Technical Review Committee Agenda

**CITY OF DELAND
THURSDAY MAY 16, 2024 AT 1:30 P.M.
CITY OF DELAND TRC MEETING ROOM
DELAND, FLORIDA**

City of DeLand
Z24-094
BLUE LAKE COVE
PD

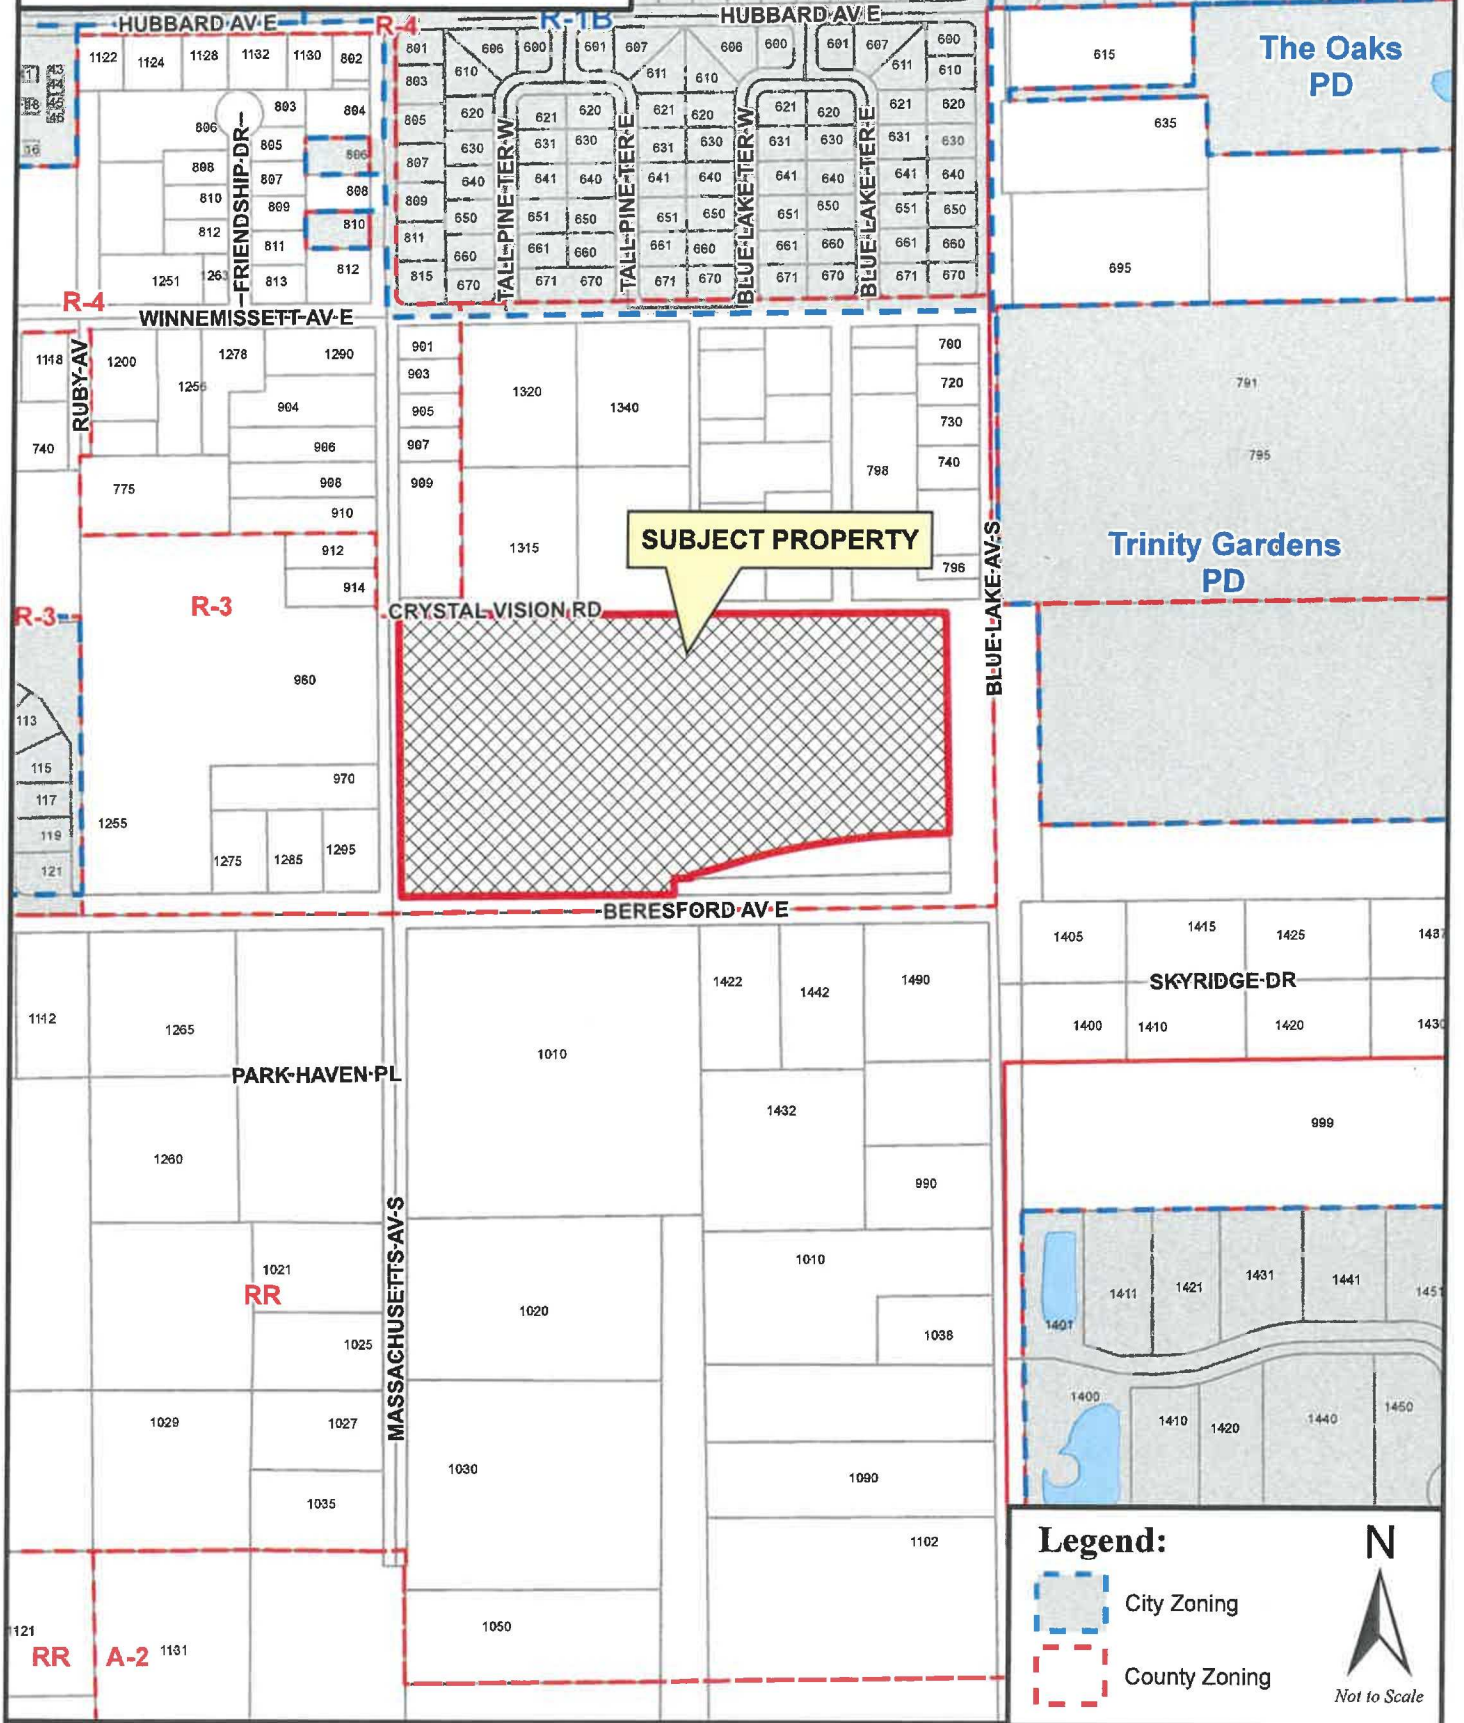
Discipline	Status	Details	Attached To	Created By	Last Updated By	Modifications Required
Engineering	Draft	Paving Section H.4. Parking Standards of the PD Agreement should include reference to the City of Deland Code Section 33-91.06(d) Paving for the allowed paved surfaces.	20240414 Blue Lake Cove PD Plan.pdf	Steven Danskine	Steven Danskine	Yes
Forestry	Draft	Tree Survey Requirements A complete tree survey of protected trees with a DBH of 6" or greater is required. It appears that a complete survey has already been performed. I would not support the acceptance of a statistical survey for a site of this size and coverage type consistency.	20240414 Blue Lake Cove PD Plan.pdf	Kit Dennis	Kit Dennis	Yes
Forestry	Draft	Tree Preservation Areas Page 11, a.- Change all references of "Tree Preservation Areas" to "Tree Protection Areas" for consistency throughout the document and to be consistent with the language in our code.	20240414 Blue Lake Cove PD Plan.pdf	Kit Dennis	Kit Dennis	Yes

Forestry	Draft	Page 10, #2. -In line 22 add the word declining between the words any and Laurel. -Add that in order to receive the reduced mitigation for declining Laurel Oaks 20" DBH or greater, an arborist report that provides the trees condition will be required. -Add that 3" caliber replacement trees will receive 2" DBH credit.	20240414 Blue Lake Cove PD Plan.pdf	Kit Dennis	Kit Dennis	Yes
Forestry	Draft	"TPA" Add the abbreviation for TPAs after the first mention of Tree Protection Areas. On page 9, line 9 add (TPAs) after Tree Protection Areas, then you can use the abbreviation throughout the document.	20240414 Blue Lake Cove PD Plan.pdf	Kit Dennis	Kit Dennis	Yes
Forestry	Draft	Page 9, Line 13 How will you determine what the "net developable area" is? Will anything other than the electric transmission easements be deducted from the site area?	20240414 Blue Lake Cove PD Plan.pdf	Kit Dennis	Kit Dennis	Yes

Planning	Draft	Perimeter Buffer Please remove the perimeter landscape section on page 15(e), lines 20-23, as the buffers are stated elsewhere in the PD and conflicts with those standards.	BLC PD Agreement 4-15-24 Final.pdf	Kendall Story	Kendall Story	Yes

Discipline	Status	Details	Attached To	Created By	Last Updated By	Modifications Required
Planning	Draft	PD Amenities Per Section 33-32.01: In return for flexibility in site design and development, planned developments (PDs) are expected to include exceptional design that preserves critical environmental resources; provides above-average open space and recreational amenities; incorporates creative design in the layout of buildings, open space, and circulation; ensures compatibility with surrounding land uses and neighborhood character; and, provides greater efficiency in the layout and provision of roads, utilities, and other infrastructure. With that in mind, and the fact that there are no other amenities in the immediate area, the amenities being provided are not sufficient. Please provide details in the PD agreement of additional amenities being provided and the size of the amenity, such as a dog park, community garden, pavilion area, etc. to support the neighborhood.	BLC PD Agreement 4-15-24 Final.pdf	Kendall Story	Kendall Story	Yes

Planning	Draft	Please remove Please remove lines 17-19 on page 13 regarding mixtures of design as this is already covered in the PD.	BLC PD Agreement 4-15-24 Final.pdf	Kendall Story	Kendall Story	Yes
Planning	Draft	Storm Event PD Agreement pg 12, part K. Please add that the stormwater system shall be designed to accommodate, at a minimum, the one hundred-year, 24-hour storm event	BLC PD Agreement 4-15-24 Final.pdf	Kendall Story	Kendall Story	Yes
Planning	Draft	remove Compliance section Please remove the part 9 Compliance section. This is already covered in the agreement.	BLC PD Agreement 4-15-24 Final.pdf	Kendall Story	Kendall Story	Yes
Planning	Draft	Remove lines 19-20 Please remove the outlined verbiage from the PD (line 19-20)	BLC PD Agreement 4-15-24 Final.pdf	Kendall Story	Kendall Story	Yes
Planning	Draft	Parking Size Standards Please remove the standard parking size requirements on page 8, as this is in the code.	BLC PD Agreement 4-15-24 Final.pdf	Kendall Story	Kendall Story	Yes

Planning	Draft	Maximum Unit Size What will be the maximum size of the largest units? Please add that into the development standards that are outlined in section H.1.	BLC PD Agreement 4-15-24 Final.pdf	Kendall Story	Kendall Story	Yes

Discipline	Status	Details	Attached To	Created By	Last Updated By	Modifications Required
Planning	Draft	Enclosed Storage for Individual Units As discussed in the pre-app meeting, please provide enclosed storage for the individual units for the occupants to store their larger items, out of sight. Please add this to the Permitted Uses section and note the size.	BLC PD Agreement 4-15-24 Final.pdf	Kendall Story	Kendall Story	Yes
Planning	Draft	Landscape buffers An increased buffer width will be needed along the road frontages of Beresford and Blue Lake (Type D 40' wide). Please show this on the plans.	20240414 Blue Lake Cove PD Plan.pdf	Kendall Story	Kendall Story	Yes
Planning	Draft	Insufficient Amenities Per Section 33-32.01: In return for flexibility in site design and development, planned developments (PDs) are expected to include exceptional design that preserves critical environmental resources; provides above-average open space and recreational amenities; incorporates creative design in the layout of buildings, open space, and circulation; ensures compatibility with surrounding land uses and neighborhood character; and, provides greater efficiency in the layout and provision of roads, utilities, and other infrastructure. With that in mind, and the fact that there are no other amenities in the immediate area, the amenities being provided are not sufficient. Please provide a plan showing the locations and details of additional amenities to support the neighborhood such as a dog park, a pavilion with picnic tables and community gardens, etc.	20240414 Blue Lake Cove PD Plan.pdf	Kendall Story	Kendall Story	Yes

Planning	Draft	3rd Access Point There is a 3rd access point shown at the northwest corner of the PD concept plan that is not noted in the PD. Please add this to the PD.	20240414 Blue Lake Cove PD Plan.pdf	Kendall Story	Kendall Story	Yes
Planning	Draft	15% TPA Each Phase Illustrate the location of all tree protection areas and their approximate size. The TPA must be a combined 15% of the site area, by Phase	20240414 Blue Lake Cove PD Plan.pdf	Kendall Story	Kendall Story	Yes
Planning	Draft	Bicycle parking PD Agreement: Please add to the PD that a bicycle parking space shall be 4'x6' and shall provide for locking up to 2 bicycles to a bicycle rack or a bicycle locker that can store up to two bicycles per unit. Concept Plan: show location of bike parking.	20240414 Blue Lake Cove PD Plan.pdf	Kendall Story	Kendall Story	Yes
Planning	Draft	Covenant Please provide the POA covenant.	20240414 Blue Lake Cove PD Plan.pdf	Kendall Story	Kendall Story	Yes

Discipline	Status	Details	Attached To	Created By	Last Updated By	Modifications Required
Planning	Draft	No burning In PD Agreement, please add the below section. On-Site Burning of Cleared Vegetation Prohibited: Vegetation and other biomass cleared from the Property during development may not be incinerated on-site.	20240414 Blue Lake Cove PD Plan.pdf	Kendall Story	Kendall Story	Yes
		Phasing FYI: Each phase will be required to meet the development standards individually. Tree protection area parking landscaping open space etc.	20240414 Blue Lake Cove PD Plan.pdf	Kendall Story	Kendall Story	Yes
Planning	Draft	Open space by phase How many acres will there be in each phase? Please provide a breakdown of the acreage, by phase, of the open space allocation.	20240414 Blue Lake Cove PD Plan.pdf	Kendall Story	Kendall Story	Yes
Planning	Draft	Laundry Will the laundromat services be free or will residents have to pay? If it is for residents only, how will you stop non-residents from using the laundromat facilities?	20240414 Blue Lake Cove PD Plan.pdf	Kendall Story	Kendall Story	Yes

Planning	Draft	BBQ/Retention area The BBQ area of Phase 2 appears to be retention area. Please clarify.	20240414 Blue Lake Cove PD Plan.pdf	Kendall Story	Kendall Story	Yes
Planning	Draft	Landscaping for shared areas Please provide a general landscape plan for the internal greenspace and building perimeter(s)	20240414 Blue Lake Cove PD Plan.pdf	Kendall Story	Kendall Story	Yes
Planning	Draft	floor plan Please provide a floor plan, with square footage. Will these be single story or multi-level?	20240414 Blue Lake Cove PD Plan.pdf	Kendall Story	Kendall Story	Yes
Planning	Draft	Elevations Please provide the following elevations and/or renderings of: -each housing design (360 degrees) -green space, amenities and landscape plans -decorative lighting on homes, walkways and amenity areas (a complete photometric plan will be required at site plan/subdivision plan)	20240414 Blue Lake Cove PD Plan.pdf	Kendall Story	Kendall Story	Yes
